# HISTORIC AND DESIGN REVIEW COMMISSION

**HDRC CASE NO:** 2022-118  
**ADDRESS:** 508 N OLIVE ST  
**LEGAL DESCRIPTION:** NCB 571 BLK 5 LOT S46 FT OF N 102 FT OF 9-10 ARB A19  
**ZONING:** RM-4, H  
**CITY COUNCIL DIST.:** 2  
**DISTRICT:** Dignowity Hill Historic District  
**APPLICANT:** 508 N OLIVE ST SERIES  
**OWNER:** 508 N OLIVE ST SERIES  
**TYPE OF WORK:** Construction of a rear addition, rehabilitation, exterior modifications  
**APPLICATION RECEIVED:** April 04, 2022  
**60-DAY REVIEW:** Not applicable due to City Council Emergency Orders  
**CASE MANAGER:** Edward Hall

## REQUEST:

**RIGHT SIDE ELEVATION**  
 SCALE: 1/4" = 1'-0"

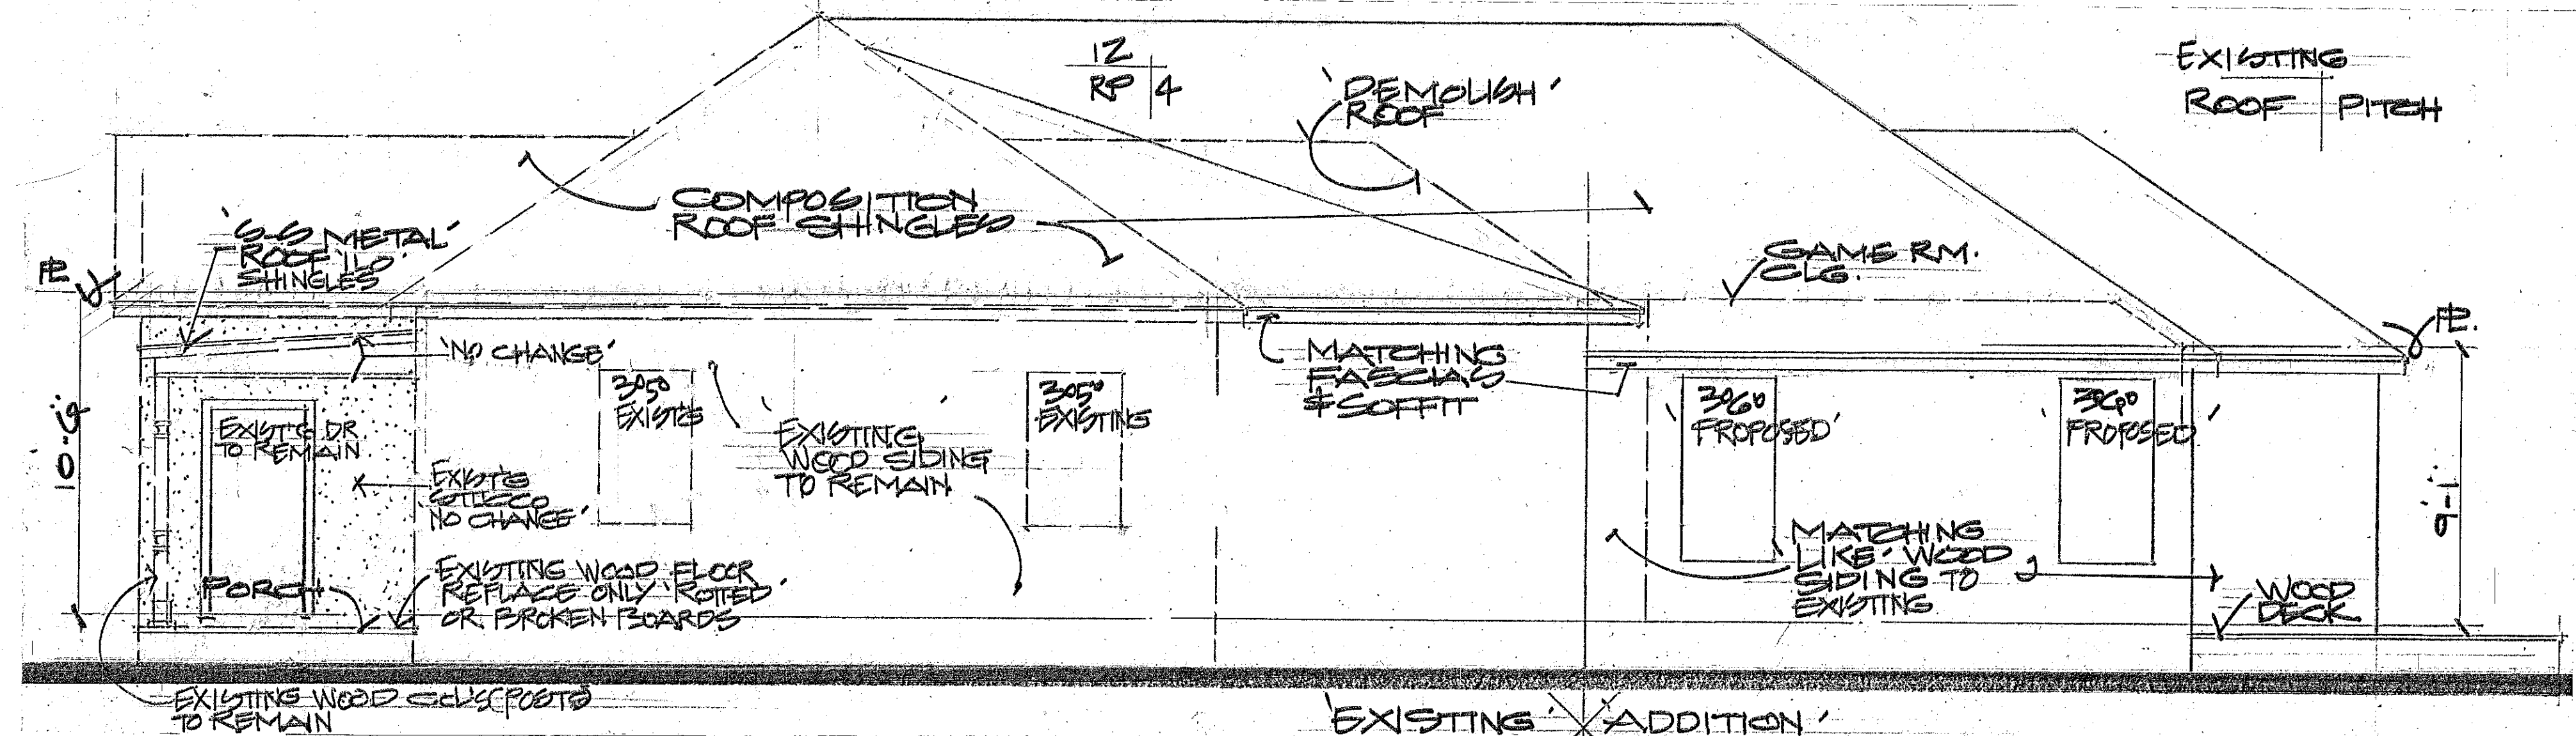
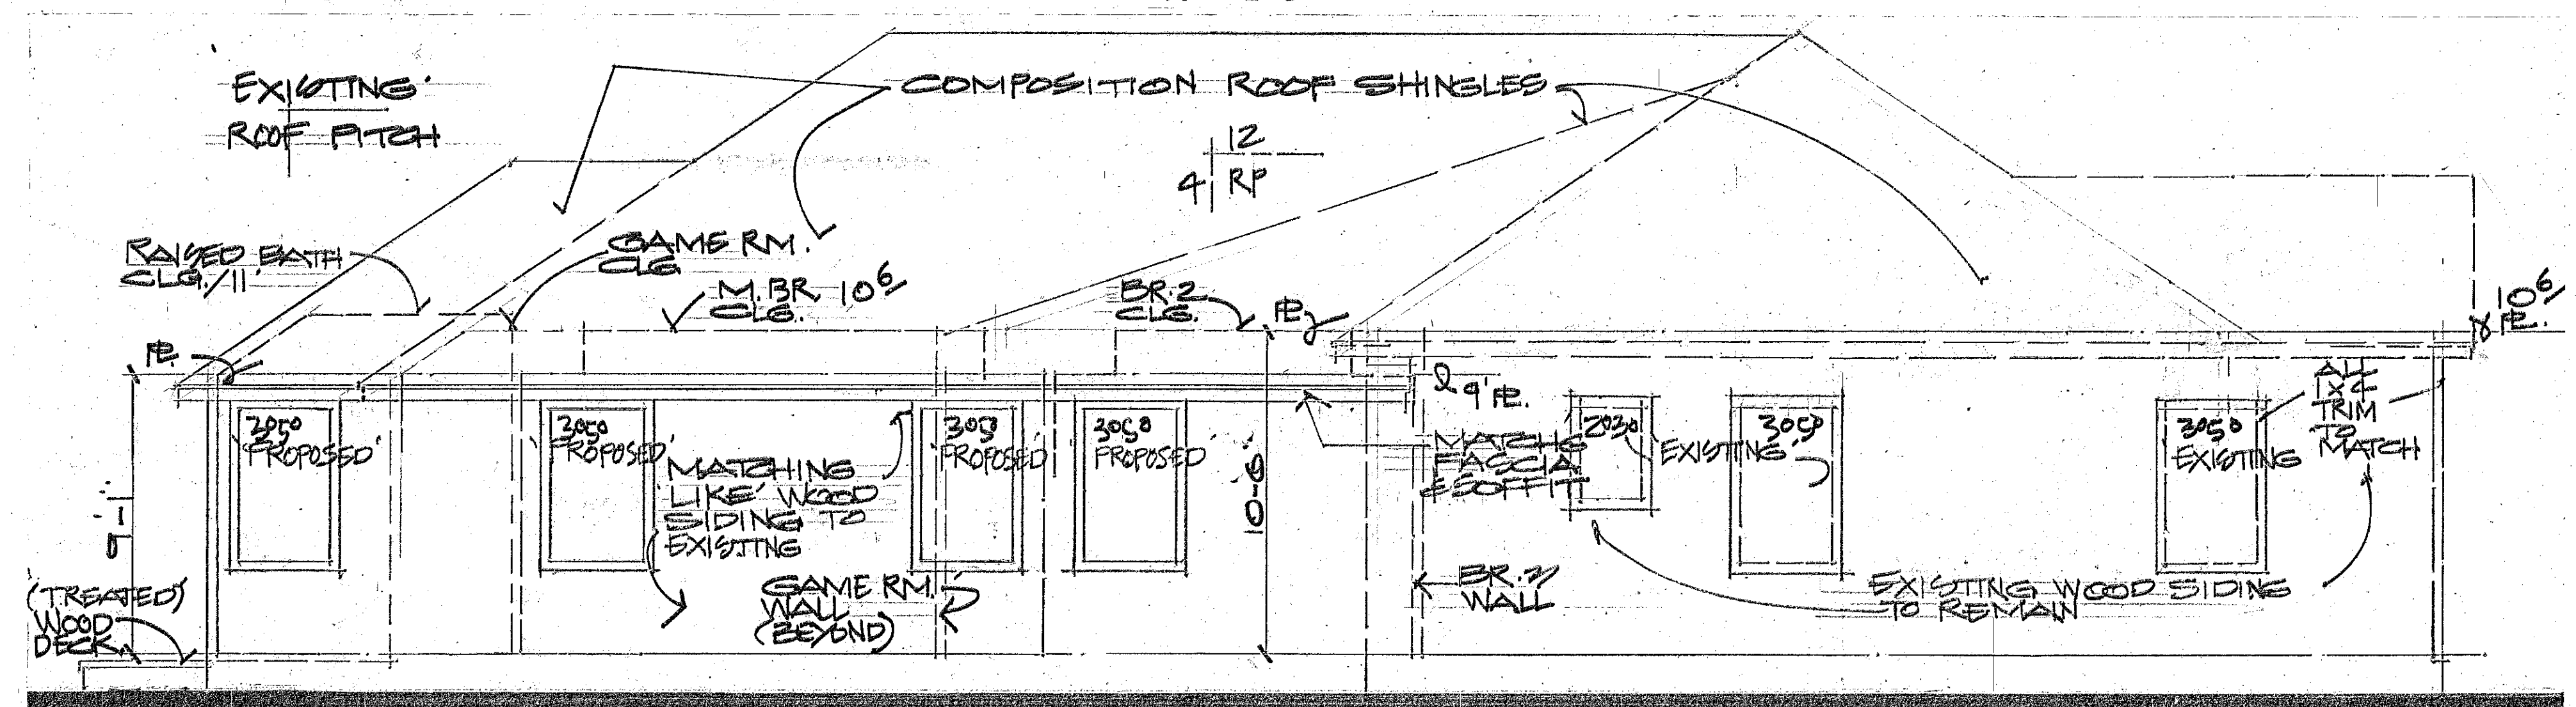
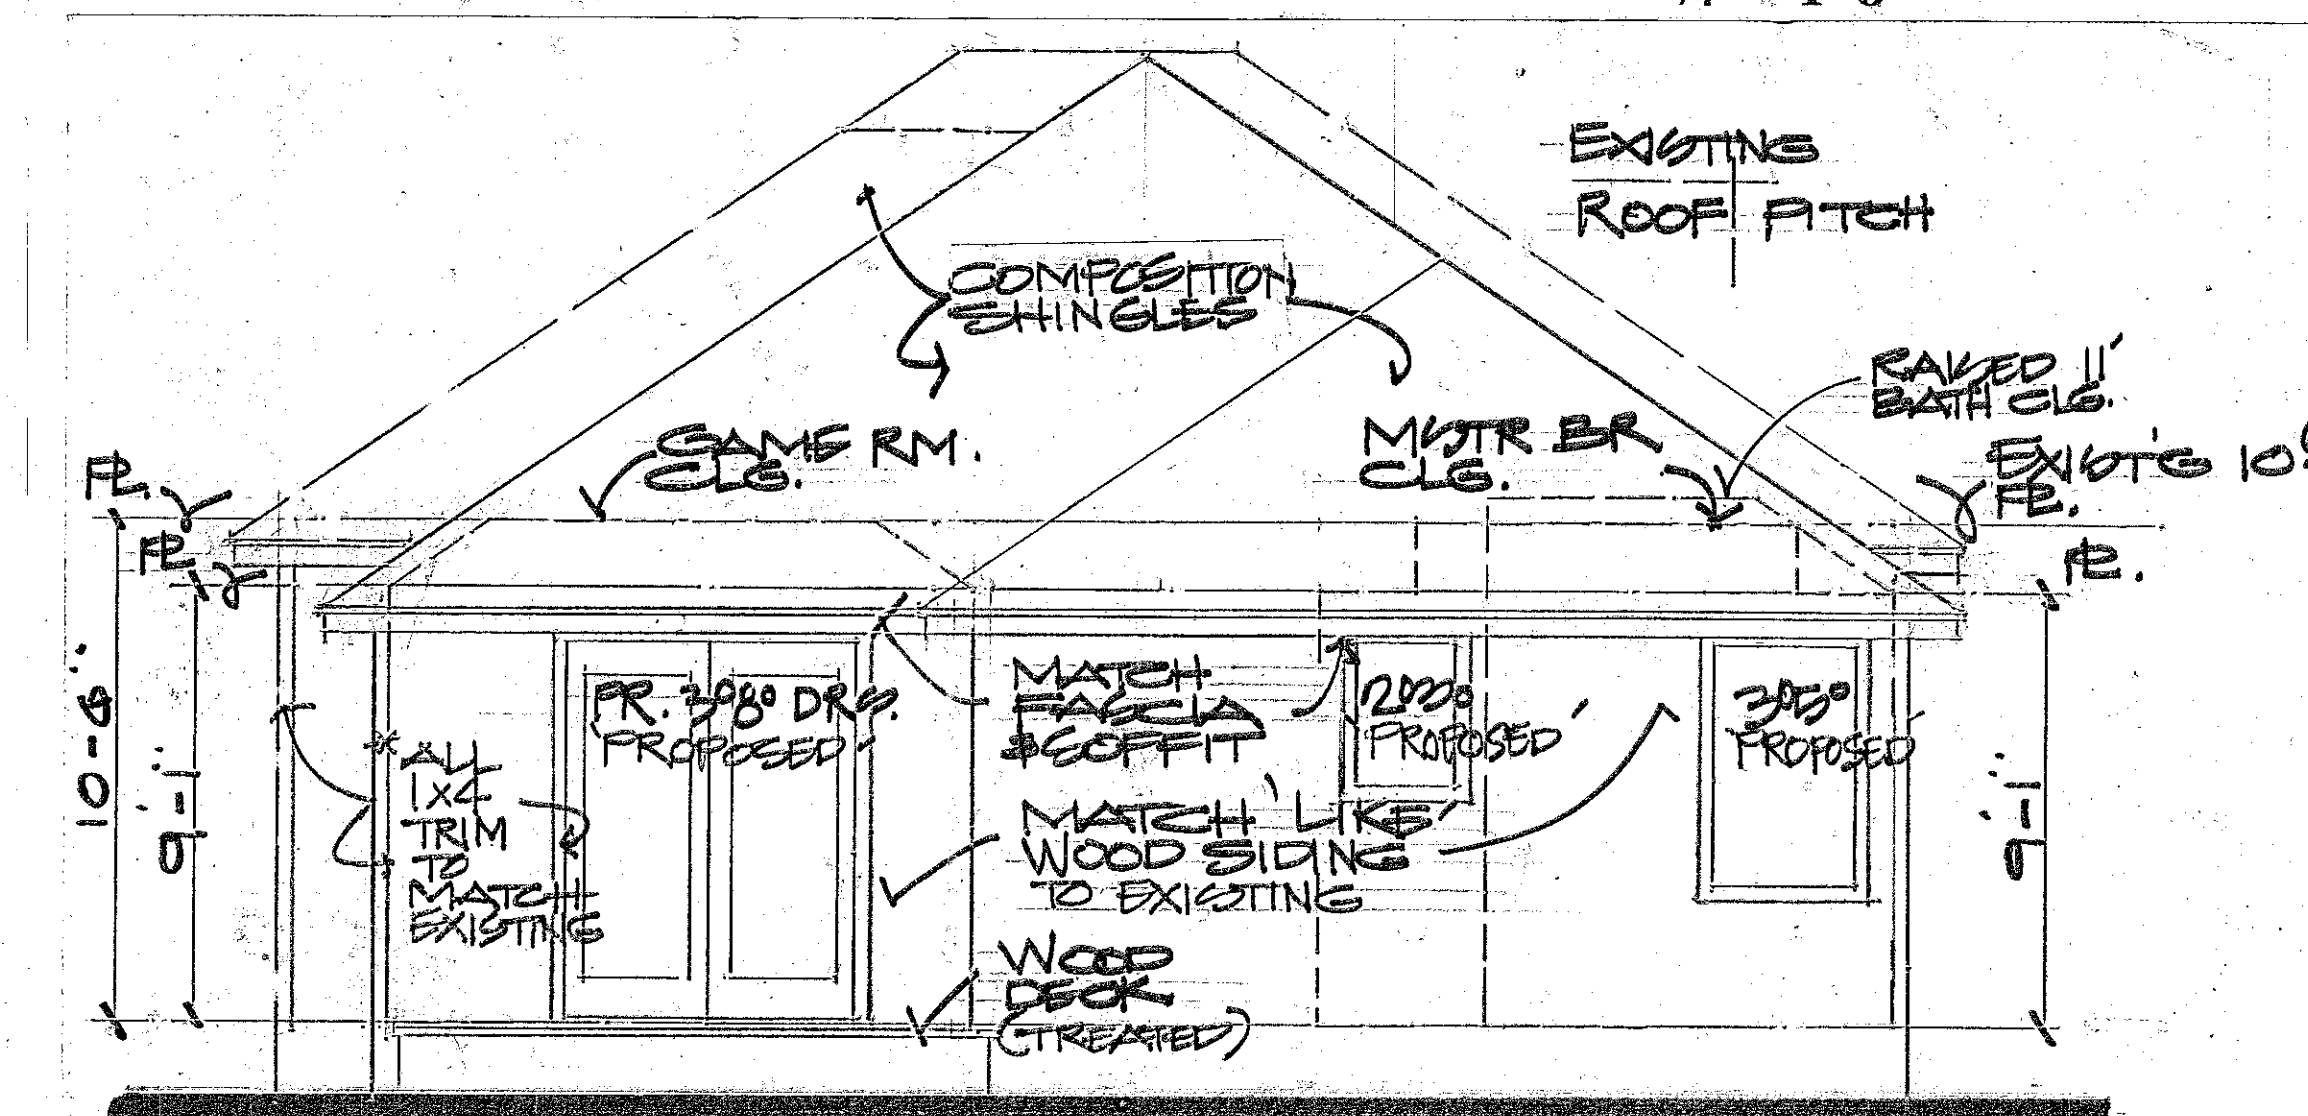
- k. ARCHITECTURAL DETAILS – Generally staff finds the proposed architectural details to be appropriate; however, staff finds that the proposed roofing should consistently be one material. Additionally, staff finds that a vertical trim piece or similar detail be added to the north façade to separate the addition from the historic structure.

5. Staff recommends approval of item #5, the construction of a rear addition based on findings f through l with the following stipulations:
  - i. That either a setback or vertical trim piece be added to the north façade to differentiate the addition from the historic structure.
  - ii. That wood or aluminum clad wood windows be installed that are consistent with staff's standards for windows in new construction and additions. An aluminum window may be appropriate should it be consistent with staff's standards for windows in new construction and additions.
6. Staff recommends approval of item #6, the installation of a ribbon strip driveway with the stipulation that only one set of ribbon strips are installed and that they are aligned with the curb cut and driveway apron.
